AGENDA
PLANNING AND ZONING COMMISSION MEETING
CITY OF CREVE COEUR, MISSOURI
MONDAY, NOVEMBER 16, 2015
7:00 PM

**APPLICATION TO PLANNING AND ZONING COMMISSION
#14-022 FOR REVISED SITE DEVELOPMENT PLAN APPROVAL
AT THE SHOPPES AT WESTGATE**

RE: Revised Site Plan & Landscape Plan submittal for application # 14-022, Shoppes at Westgate, 12410-12428 Olive Boulevard (southwest corner of Olive Boulevard and Tempo Drive)

Figure 4: Close-up of the proposed landscape plan along Olive Boulevard.

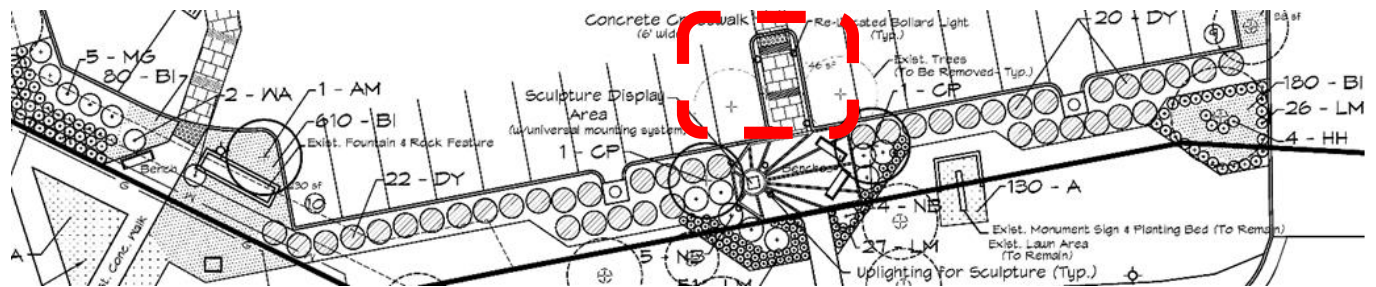
The Landscaping is consistent with the minimum requirements of a green line park and the requirements of Section 405.540 Landscaping of the City's Zoning Ordinance and Section 405.810(5), with a straight line of evergreen hedge along the parking area when adjacent to the right-of-way. But it lacks the diversity of the prior landscape plan relied on in prior approval for site coverage bonus, as shown below. The Applicant is providing for additional plantings at the corner, however, the area along the parking spaces in particular lacks a variety of plant design.

5. A final landscape plan shall be submitted that provides for additional plantings and diversity along Olive Boulevard frontage adjacent to the parking area prior to the issuance of site improvement permits.

Figure 6: Close up of the Sculpture Display Area and Seating area

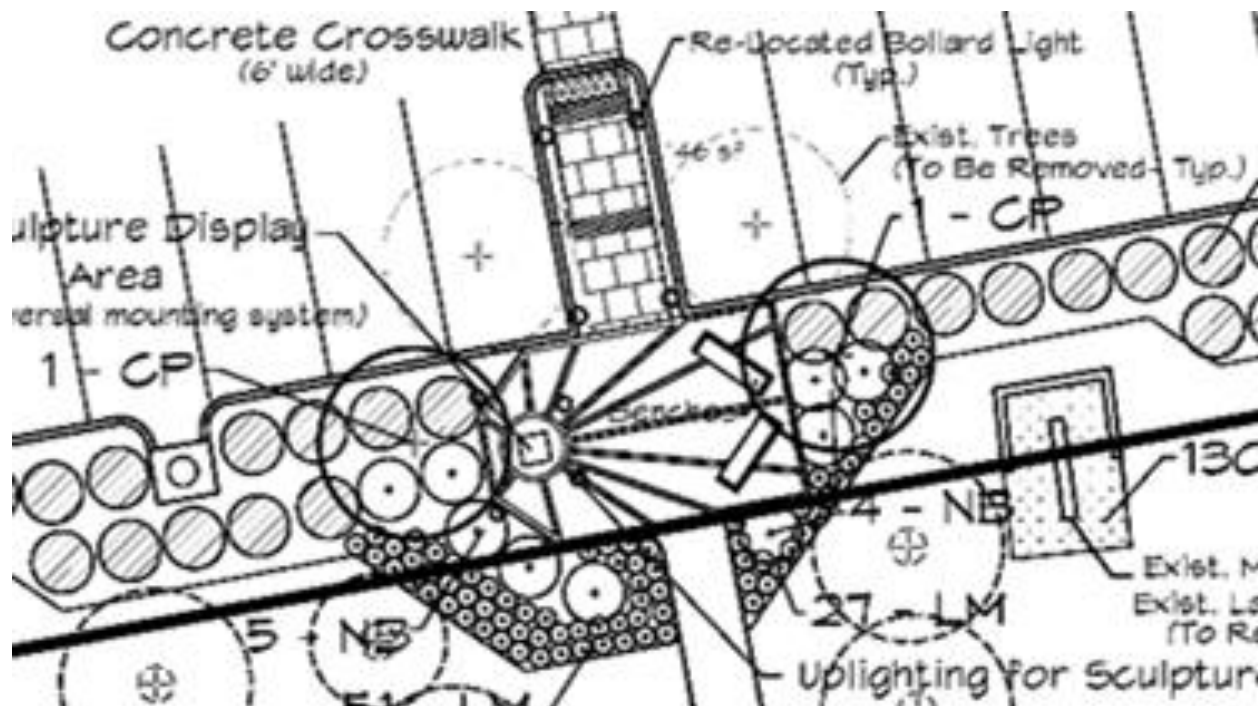
The inclusion of the public art is a new feature and includes relocation of the existing plaza seating area that existed between the parking spaces. However, Staff recommends that it be slightly expanded to equate to the size of the former pedestrian area and to allow more room for viewing of the art pieces.

Figure 4: Close-up of area to be removed for additional parking

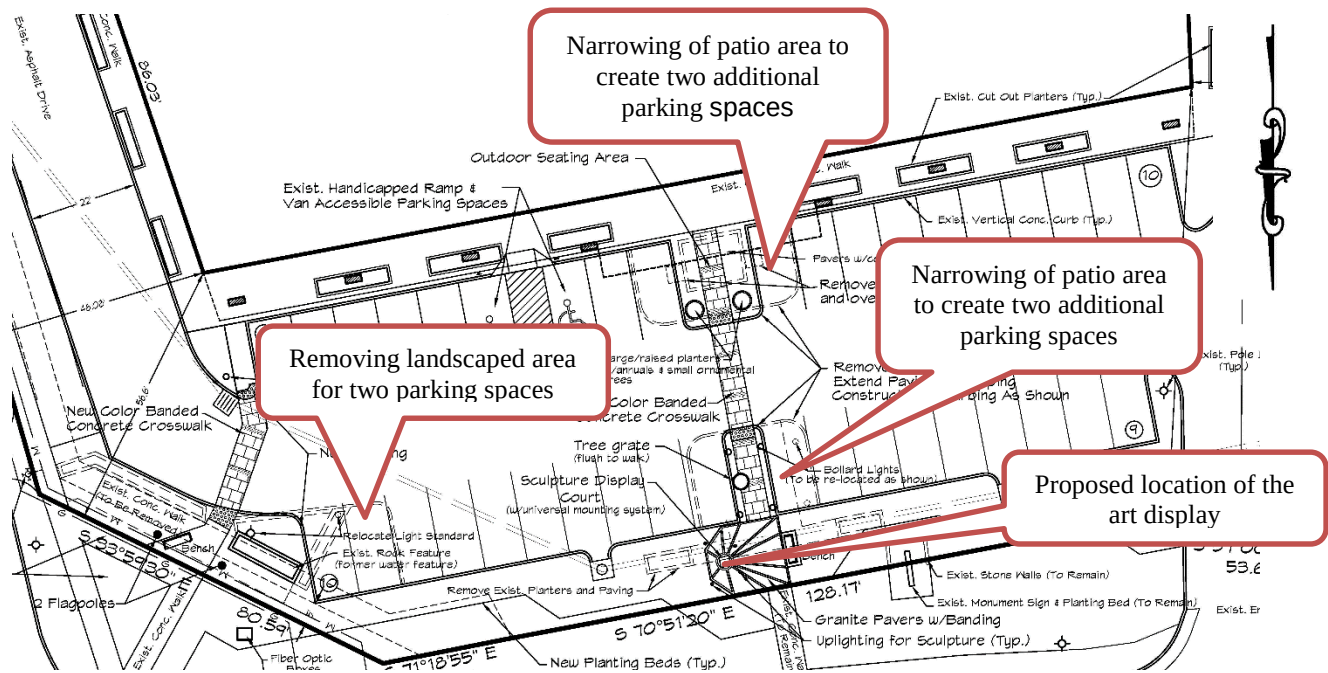
The Applicant is seeking to remove the canopy element on the front of the building and replace it with a standing seam pre-finished metal awning and further to narrow the plaza area adjacent to the building and across the drive aisle to create four additional parking spaces, per the drawings below:

Figure 7: Close up of the proposed changes to the plaza area at the front/entrance of the building.

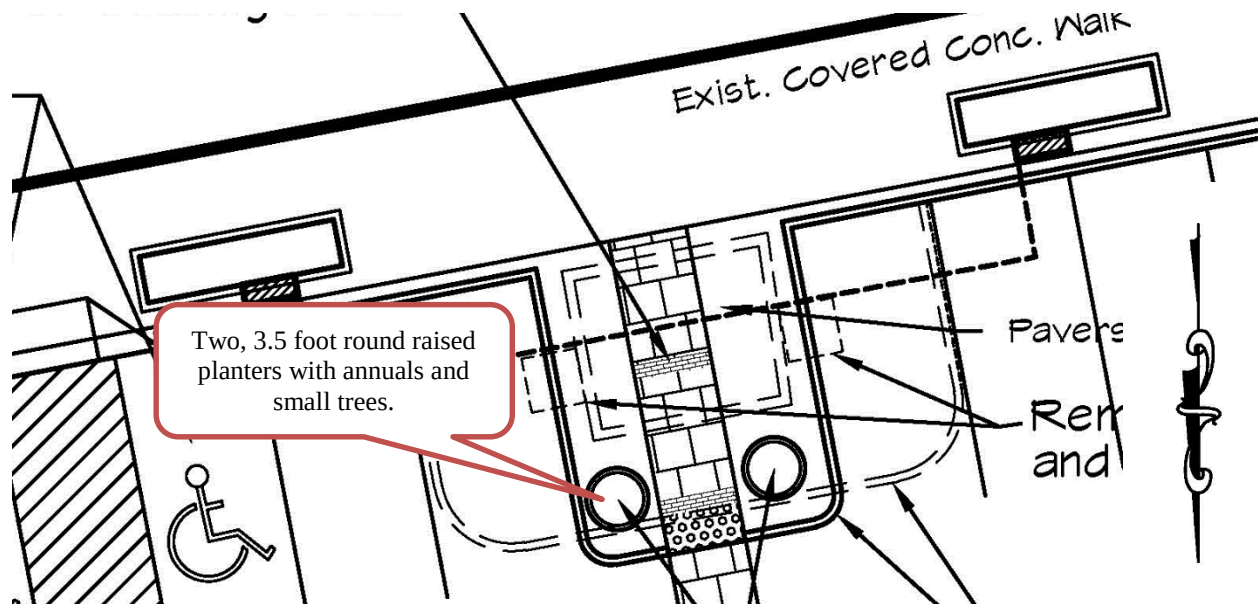
The plaza/dining area proposal include removing the existing planters, narrowing the overall space and adding two round raised planter with annuals and small ornamental trees:

Figure 8: Close-up of the Site Plan of the middle sidewalk from Olive to the building entrance.

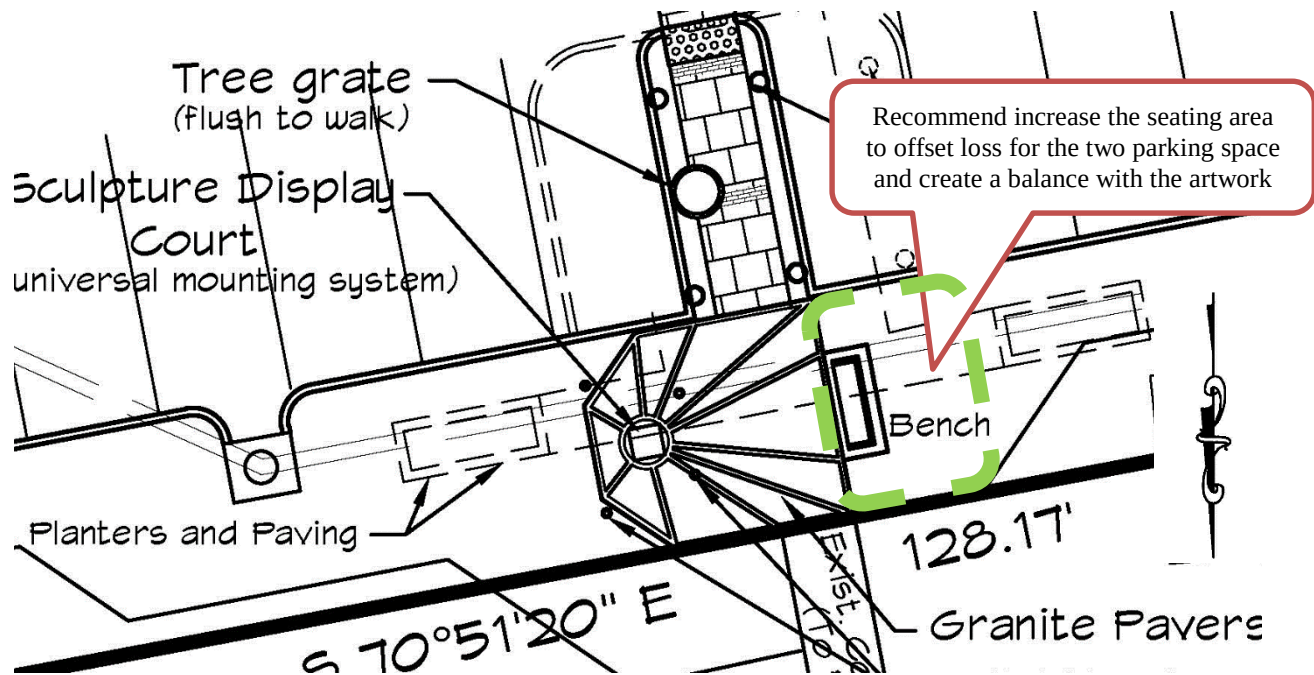
Section 405.730(A)(2) of the Zoning Ordinance states that the minimum width of internal sidewalks in non-residential developments shall be at least six feet or eight feet if used as a curb stop. The site plan indicates that the sidewalks are five feet in width. However, they are not adjusting most of the sidewalks already on site. However the pedestrian connection within the newly created plaza seating is maintaining a five foot path, and across the drive aisle along Olive, and the tree grate narrows it further to three feet, per the image below:

Staff recommends that any new sidewalk area shall have a minimum of six feet in width to meet with the minimum standards of the Code. As mentioned above the location of two tree may be moved to in front of the stall and low landscaping provided on either side of the walkway. The loss of plaza seating at this location should be shifted to sculpture display area, by increasing the seating area and create balance.

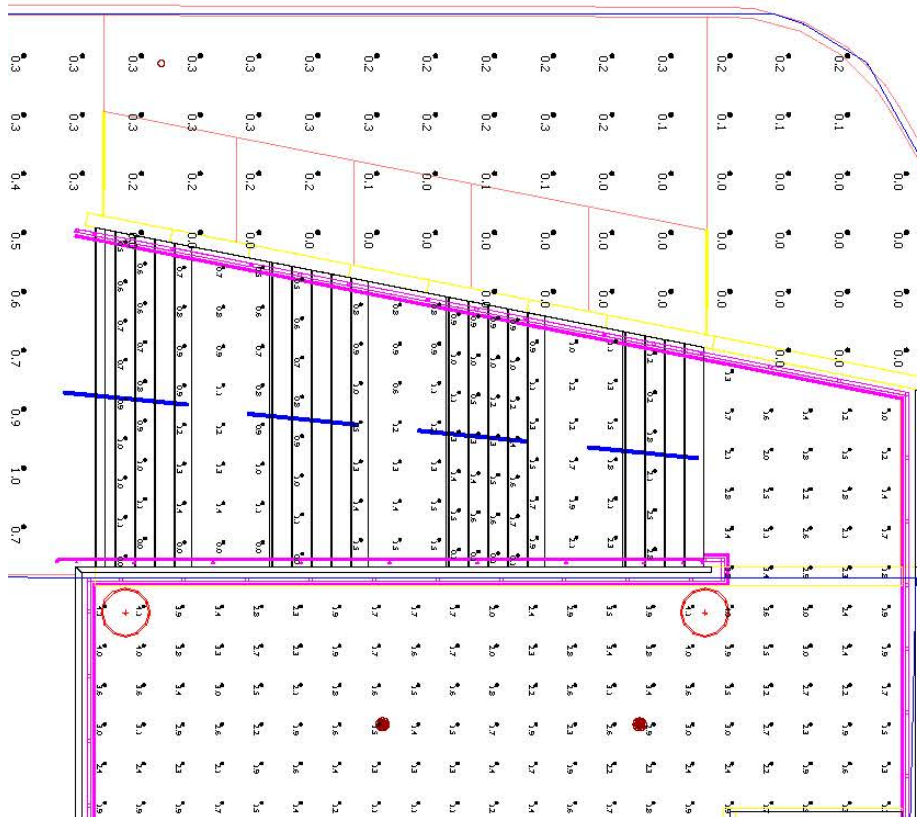
The proposed light element will have a greater cutoff greater than the allowed. While the lighting is directed downward, by the use of the aluminum shield, the light measurements submitted has a Candlepower Distribution table showing: 197.8 candela at 75 degrees, 23.2 candela at 90 degrees, and 1.5 at 180 degrees. The photometric plan indicates an illumination of 0.3 at the new downstairs walkway, and does not cast upon adjacent property, per the image below:

The new deck is approximately 144 feet from the residential property to the west. And approximately 108 feet from the east property line along Lindbergh Boulevard.
